**Oxley Solar Farm**

# **Amendment Report**

**November 2022**

**Project Number: 21-393**

Figure 6-3 Comparison of the layout assessed in the EIS and the now refined Development footprint assessed in this Amendment report

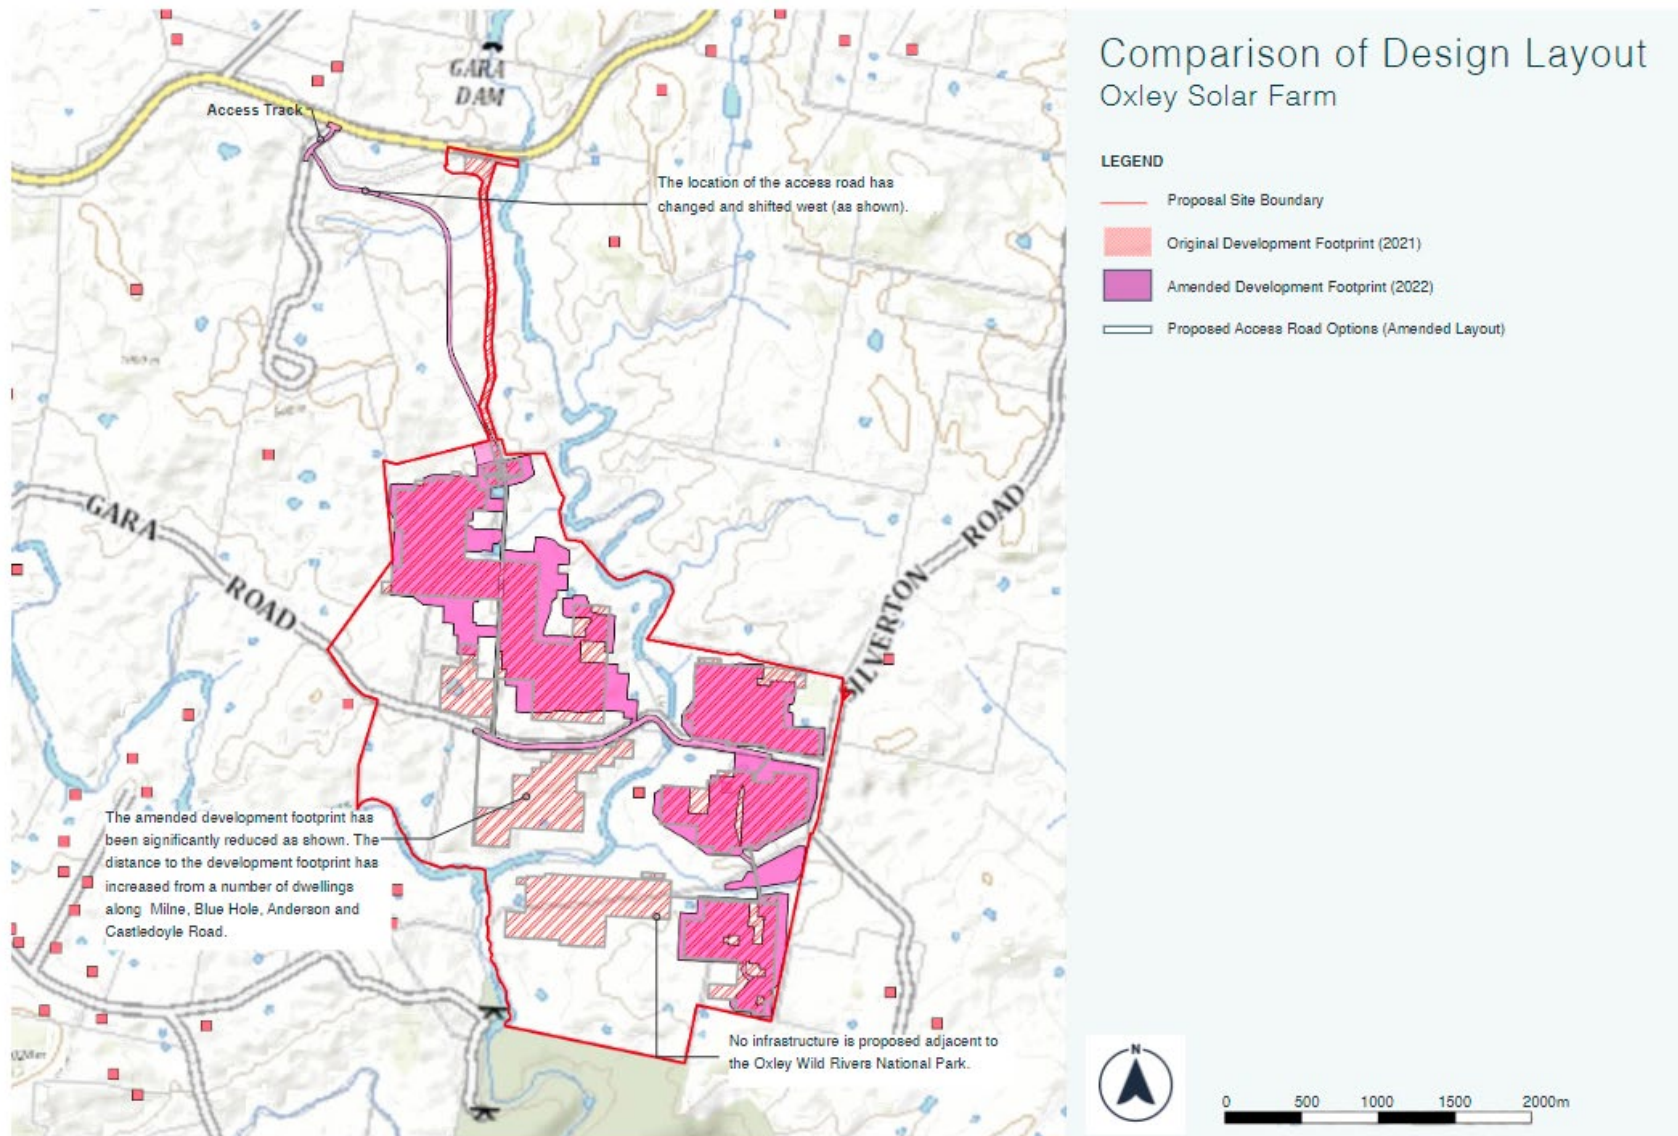
In response to the public and agency submissions, the Oxley Solar Farm has made substantive additional changes to the Proposal. Relevant to reducing visual impacts, these included a reduced development footprint and solar panel area. Specifically:

In relation to visual impacts, the key changes are quantified in Table 6-3 and Figure 6-3.

Figure 6-21 Aerial plan view of proposed Gara Road causeway upgrade

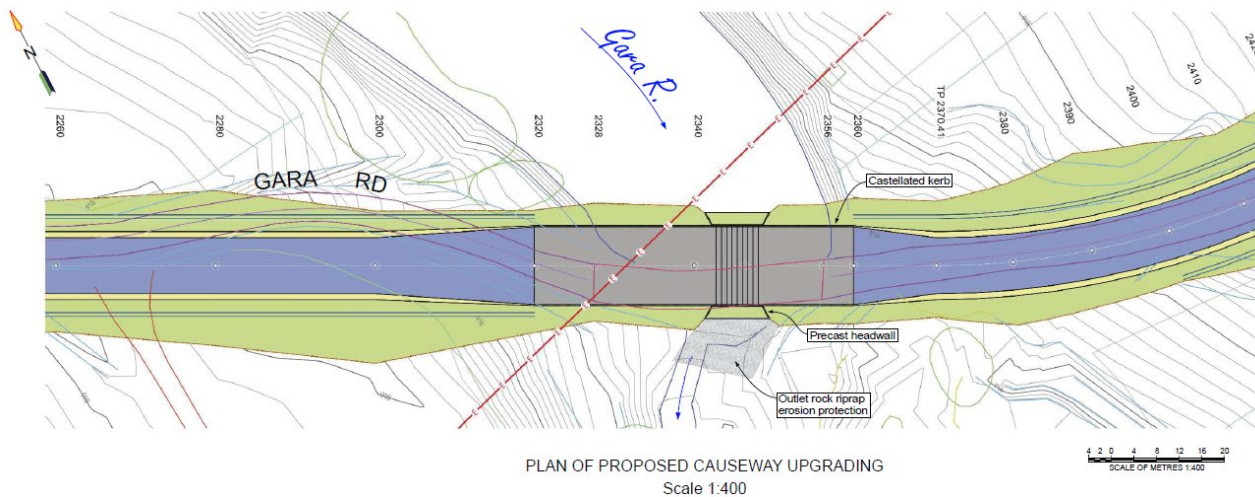
Improvements will be required along Gara Road between approximate chainages 7.78km and 9.70km, where it will be necessary for heavy vehicles to travel on Gara Road to access different parts of the Oxley Solar Farm. Such improvements would include localised widening and course straightening to allow heavy vehicles to pass, three new heavy vehicle property entrances, and upgrading in the vicinity of the Gara River causeway crossing where road width and sight distances are constrained (Figure 6-20). The access points will be in compliance with Austroads intersection guidelines and the Armidale Regional Council Engineering. Given there is little through-access at this part of the road, consideration could be given to temporary traffic control measures to control traffic in the vicinity of the Gara River crossing, in consultation with Armidale Regional Council.

The proposed causeway upgrading work aims to improve road safety, amenity and flood immunity, avoiding the need for vehicles to queue on approaches under traffic control or for 'wet' causeway crossings, while ensuring the structure requires minimal ongoing maintenance and is commensurate with long term traffic needs. The causeway would involve raising the road by up to 1.3m, that would include culverts as shown in the concept design in Figure 6-21.
